ASSESSMENT REPORT

Section 4.55(1A) Modification Sigma Pharmaceutical Warehouse and Distribution Facility (SSD 7719 MOD 1)

Figure 4: Proposed Warehouse Plan (Key Changes Highlighted in Red)

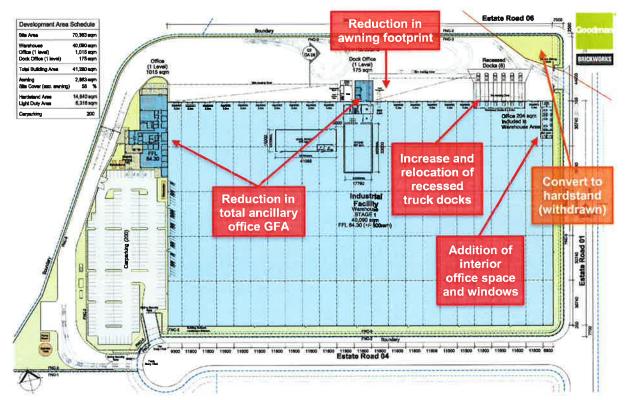
application seeks to: - amend the awnings along the northern warehouse façade	
	 relocate and increase the number of recessed truck docks add windows on the north-east corner of the warehouse 	
	 and windows on the north-east corner of the warehouse amend the ancillary office layout and reduce to one-storey. 	
	The Applicant undertook an assessment of the proposed	
	modification against the development controls of the Concept	
	Proposal (Condition B10 of SSD 6917). The assessment concluded the character, height and scale of the amended	
	warehouse would be consistent with the development controls.	
	The Department considers the warehouse façade would be visible	
	by road users and customers, but not by local residents. The	
	development is consistent with the local character as it is located within an industrial precinct.	
	The Department's assessment concludes the proposed	
	warehouse amendments would not result in additional impacts

beyond what has been assessed as part of the original application (SSD 7719) and the Concept Proposal (SSD 6917).	
	The Department recommends the approved plans within the	
	consent be updated to reflect the proposed modification.	
Manoeuvrability	The proposed modification involves relocating the recessed truck docks closer to north-east comer of the site (see Figure 4), which	Manage via existing conditions.
	has the potential to impact upon site manoeuvrability.	
	The Department raised concerns regarding site manoeuvrability	
	and noted the recessed truck docks would be closer to the	
	landscaped area, having the potential to impede the ability of trucks accessing these docks.	
	The recessed truck docks would also be closer to the emergency	
	access, having the potential to impede emergency vehicles access	
	 to the site. The Applicant provided updated swept path diagrams at the 	
	Department's request.

Figure 5: Proposed Signage Plan (Changes Highlighted in Red)

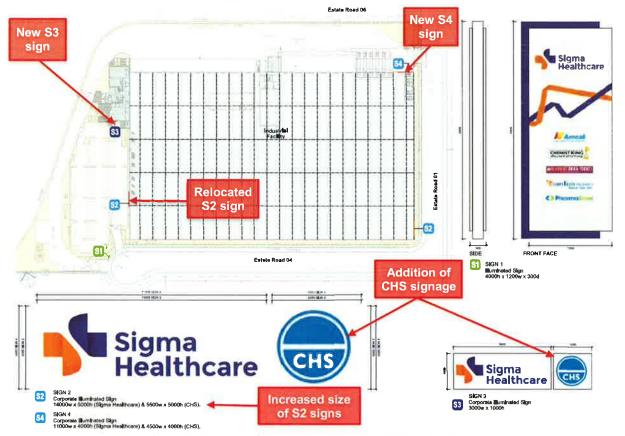
Issue	Assessment Recommendatio	n
Signage	 The proposed modification increases the overall amount of signage, which has the potential to result in visual impact due to its size, content and illumination. The proposed signage for the warehouse is depicted in Figure 5. The Department undertook an assessment of the proposed signage against the criteria of State Environmental Planning Policy No. 64 – Advertising and Signage (SEPP 64), which is summarised in Appendix D. The Department is generally satisfied the proposed signage would be consistent with SEPP 64. However, the Department was concerned the proposed signage on the western façade of the development. This signage is illuminated and oriented towards the Ropes Creek riparian corridor, having the potential to impact upon fauna. In response to the Department's concern, the Applicant proposed to illuminate this signage during certain hours. The Department agrees that restricting the illumination of the western facing signage to certain hours would minimise the potential impacts to the riparian corridor. The Department notes the neighbouring Toyota facility (SSD 7663) includes a 5.8 m high by 20.8 m wide illuminated business identification warehouse sign, similar in size to the largest sign for the proposed modification. The Department considers the proposed signage also meets the requirements of the underlying Concept Proposal (SSD 6917), which specifies that a maximum of one illuminated sign is permitted on each warehouse elevation. Illuminated signs must also be oriented away from residential receivers. 	nt to the nage the stric f the

Issue	Assessment	Recommendation
	 The Department's assessment concludes the proposed signage would provide adequate business identification and wayfinding for customers and other road users. 	
	 The Department considers the revised signage plan meets the requirements of the Concept Proposal (SSD 6917) and the 	
	assessment requirements of SEPP 64.	
	The Department recommends the conditions be modified to	
	incorporate the revised signage plan and to include restrictions on the signage illumination to daylight hours.	
Visual	The proposed modification would result in changes to the warehouse built form and consequently its presentation to the street.	Update Appendix A of the consent to include the relevant updated
	The proposed site plan is depicted in Figure 4.	plans.
	The modification application includes revised warehouse and office elevations, prepared by SBA Architects. The modification application scales to:
